REMARKS

Claims 1-6 and 11-19 are pending in this application. Claims 7-10 have been deleted. Claims 1 and 3 are independent. Claims 2, 11-14 depend from claim 1. Claims 4-6 and 15-19 depend from claim 3.

II. Rejections under 35 U.S.C. §103

Fig 1

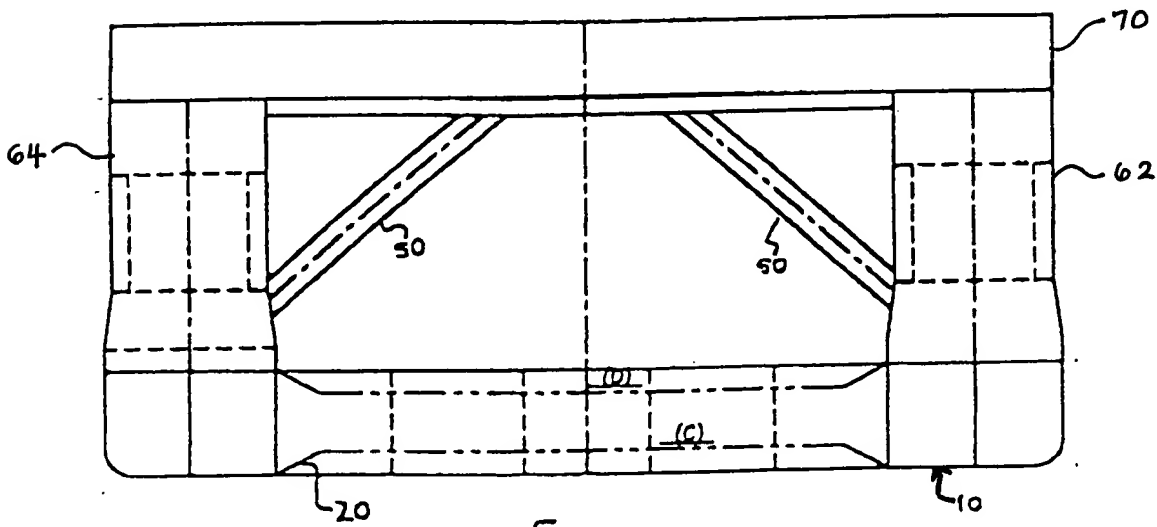
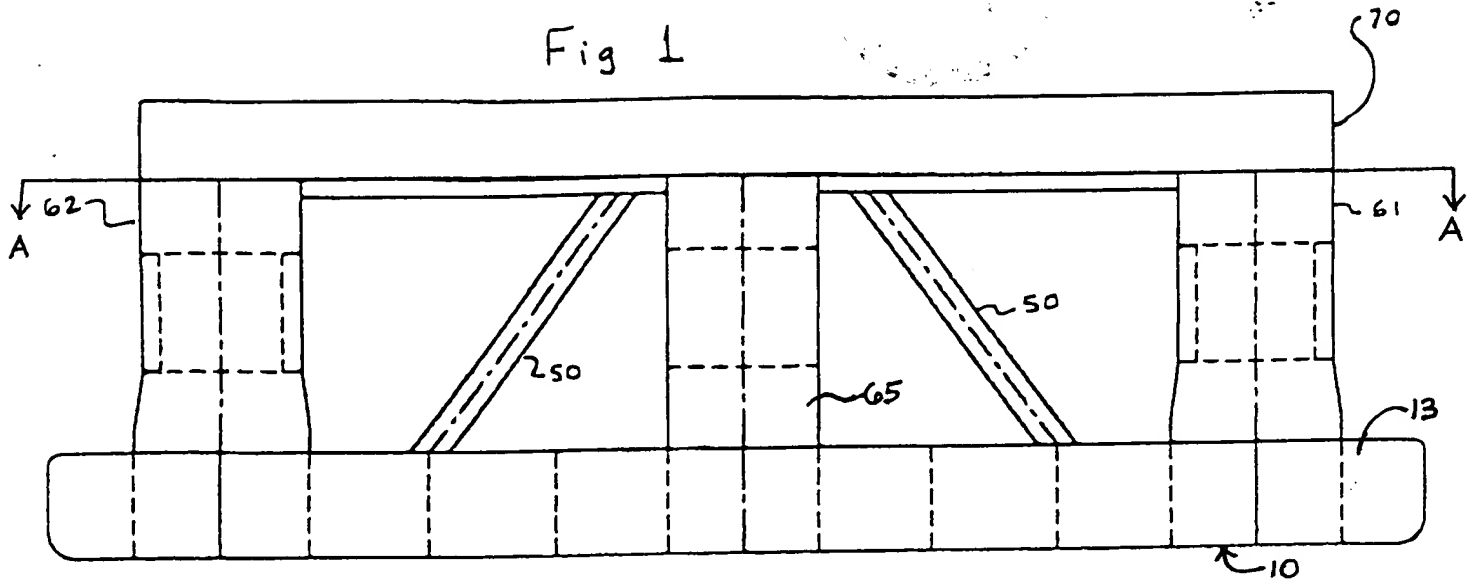
The Examiner objected to the drawings of Figures 1, 2, 5, 8, 9, and 10 because of missing section lines, improper lead lines, and missing reference numerals. The drawings of Figures 1, 2, 5, 8, 9, and 10 have been amended to include the missing section lines and reference numerals and to correct the improper lead lines. Accordingly, withdrawal of this objection is requested. Figures 3, 6, and 7 have also been amended to include missing reference numerals. Applicants believe that this amendment will facilitate understanding of the disclosure. Subsequent to the Examiner's approval, formal replacement sheets for Figures 1-3 and 5-10 incorporating these changes will be submitted to the office.

Not
app.
5/17/99

Fig. 2

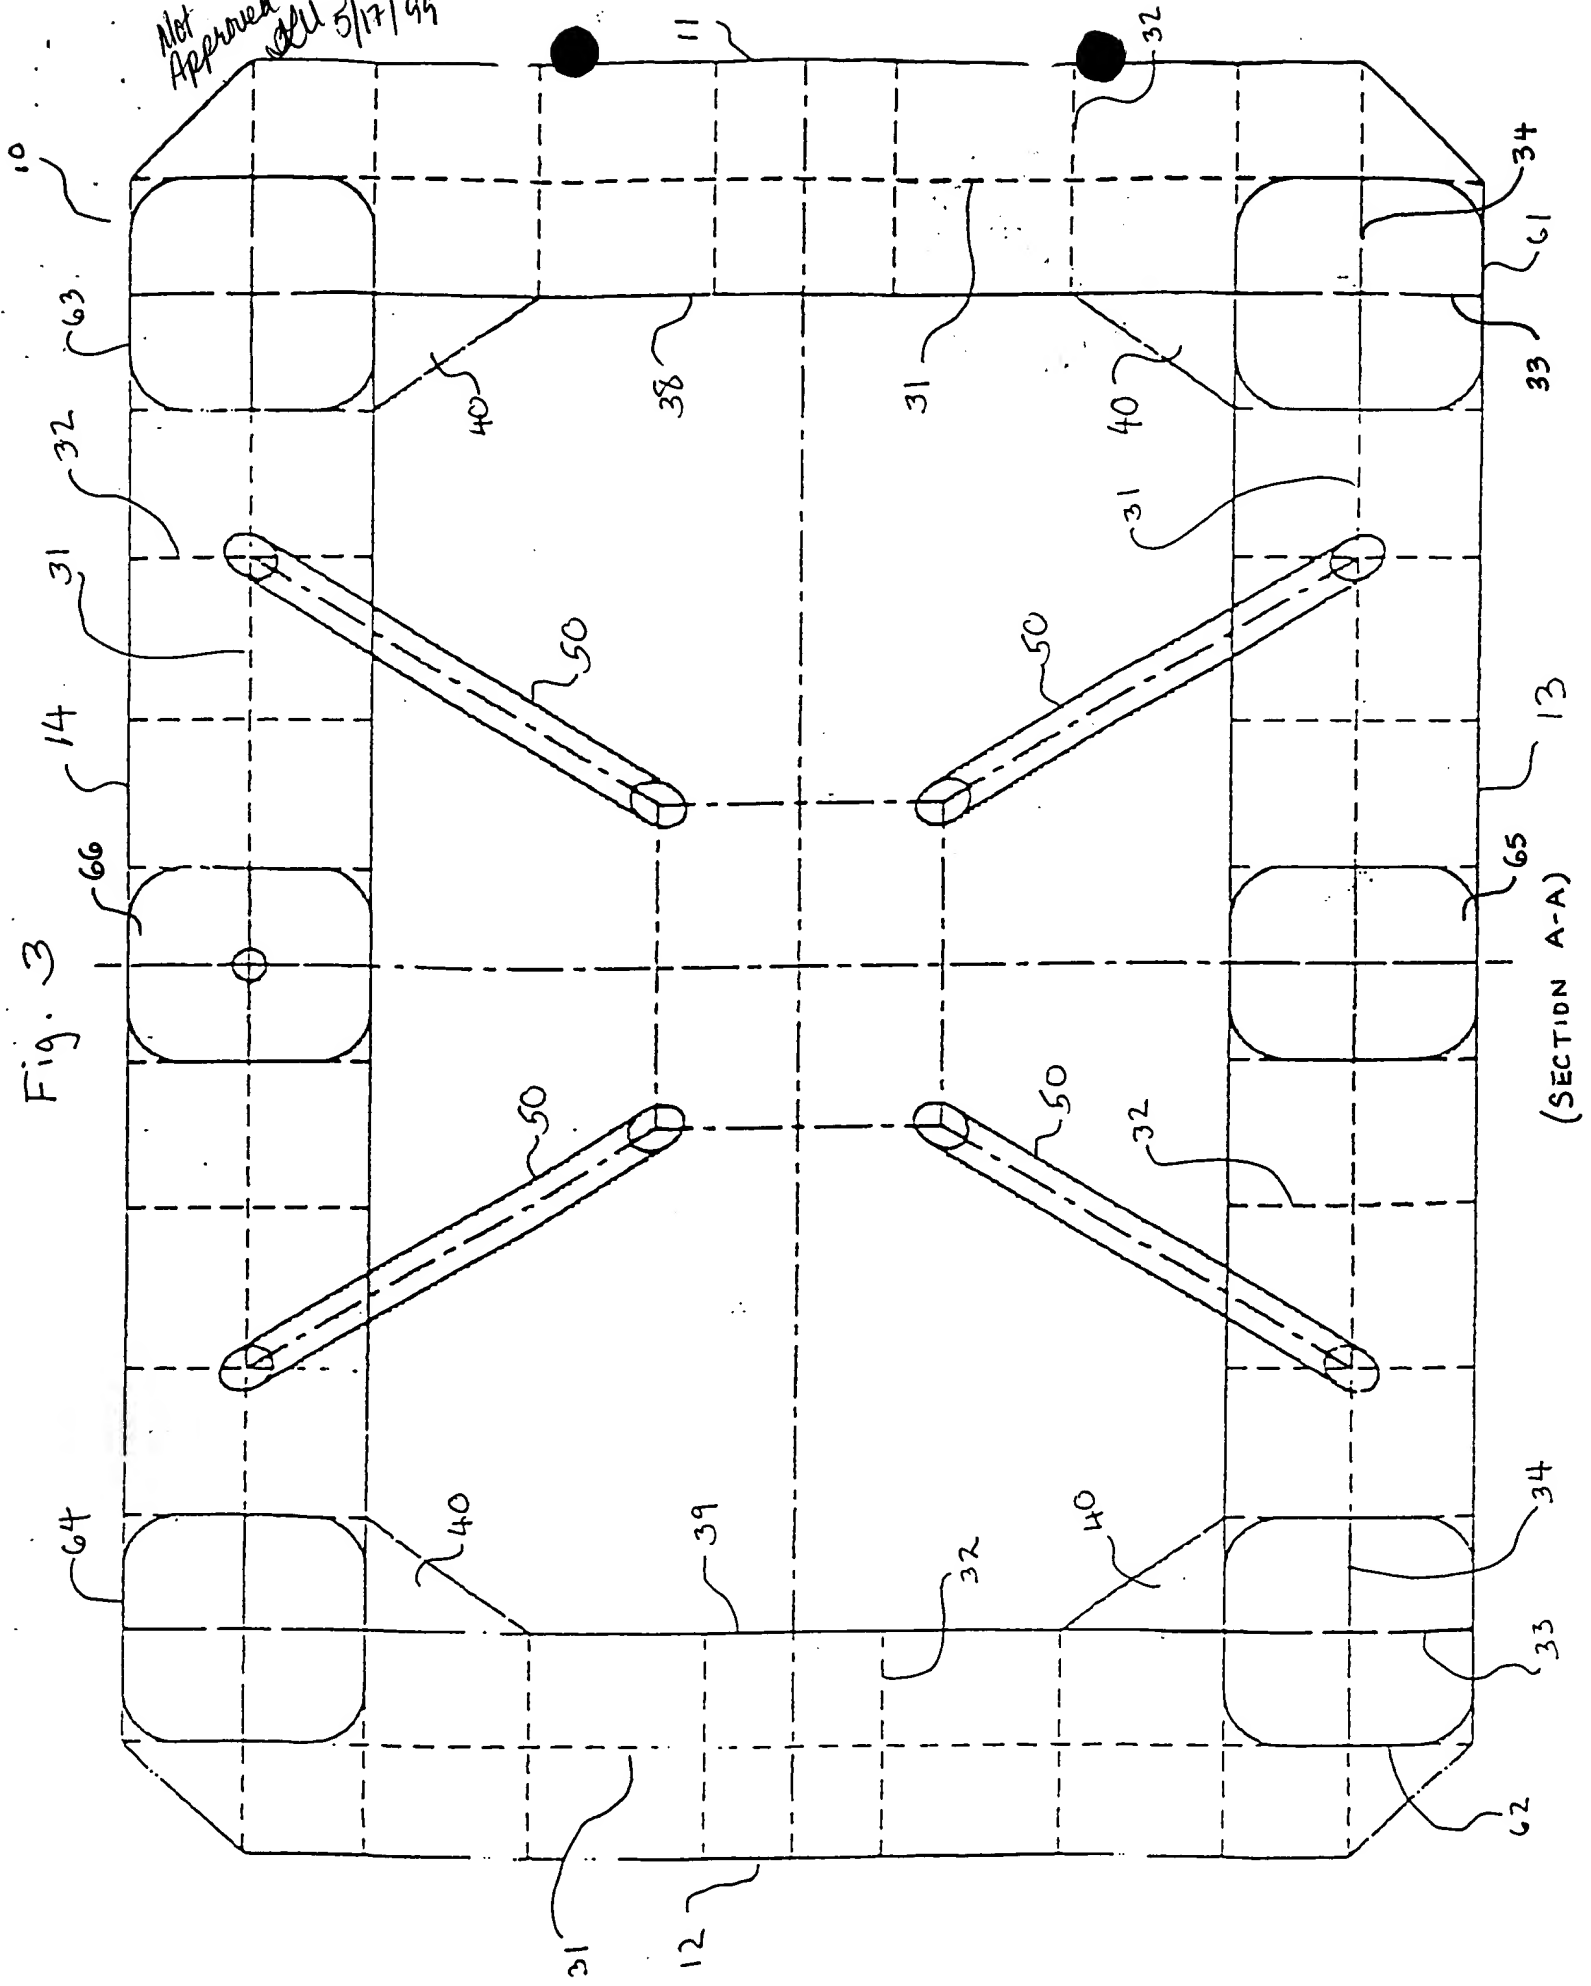
Not Approved
05/17/99

Fig. 10

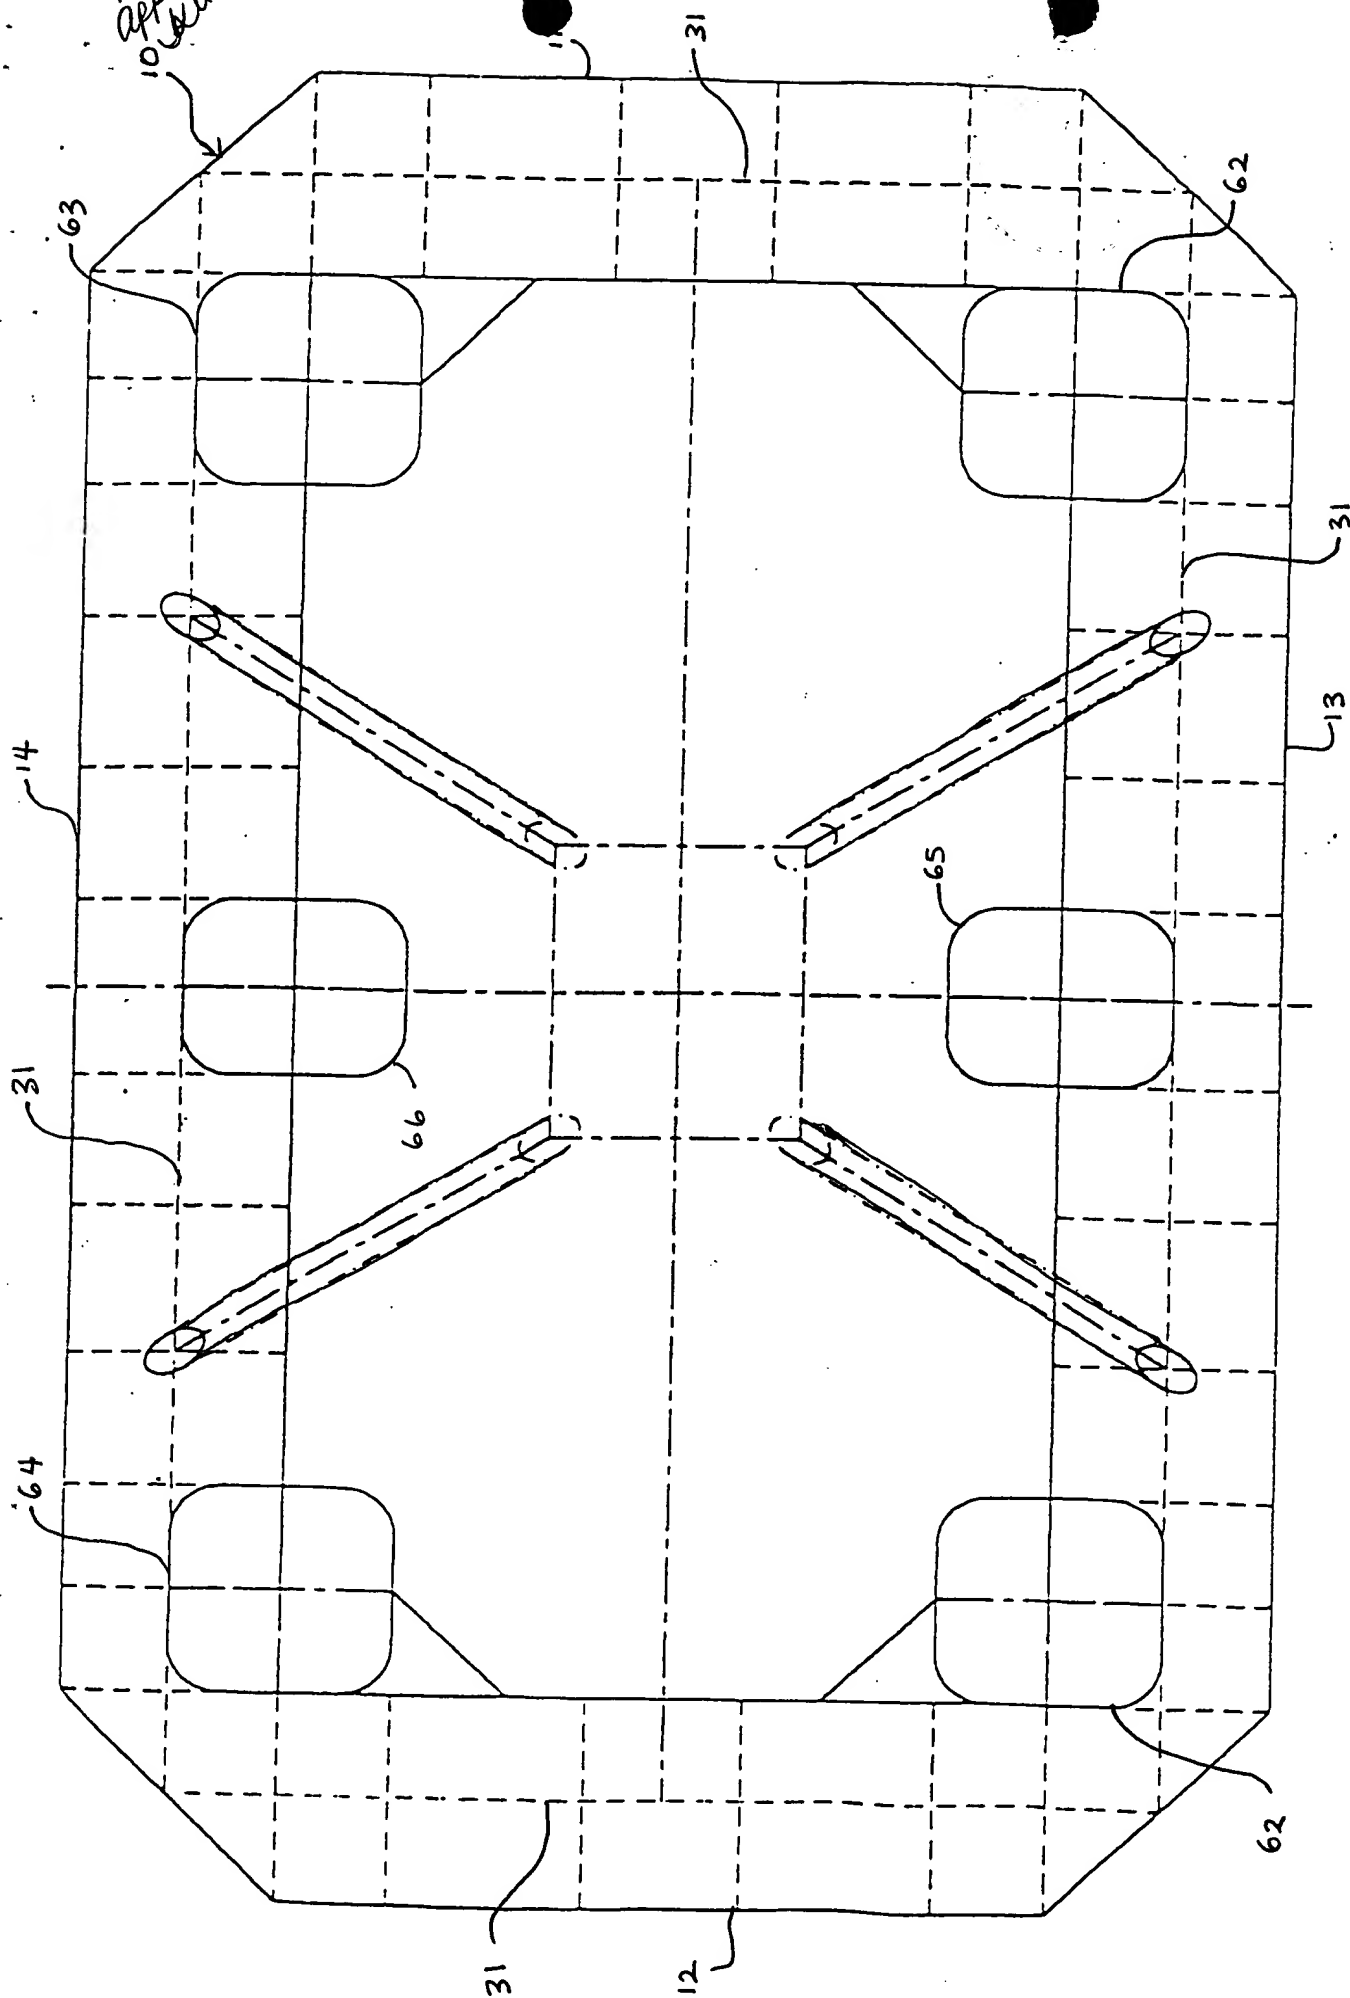
Not
Approved
10/24/99 5/17/99
